Detail at the steep-slope single-ply roof

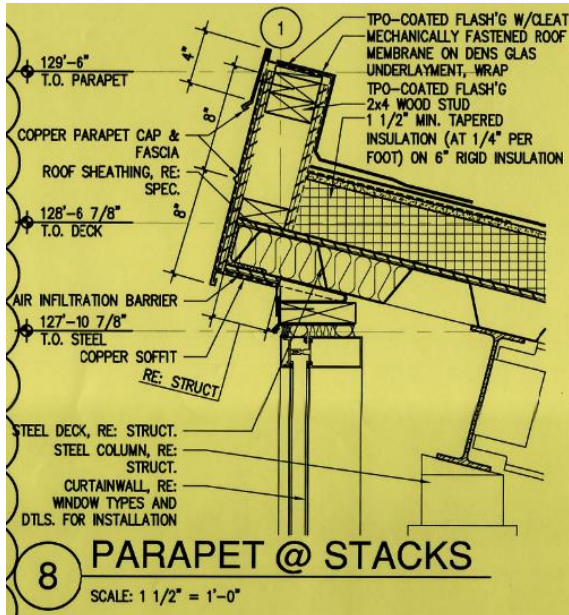
1. Please provide the existing roofing assembly for the sloped area where an option for metal is required. Our thought process is that It might not be a good idea to fasten the metal panel through multiple layers of ISO as this may be difficult to warranty.
 - a. The existing standing seam roof at the southeast corner of the building likely has fasteners through multiple layers of iso. See two existing details below.
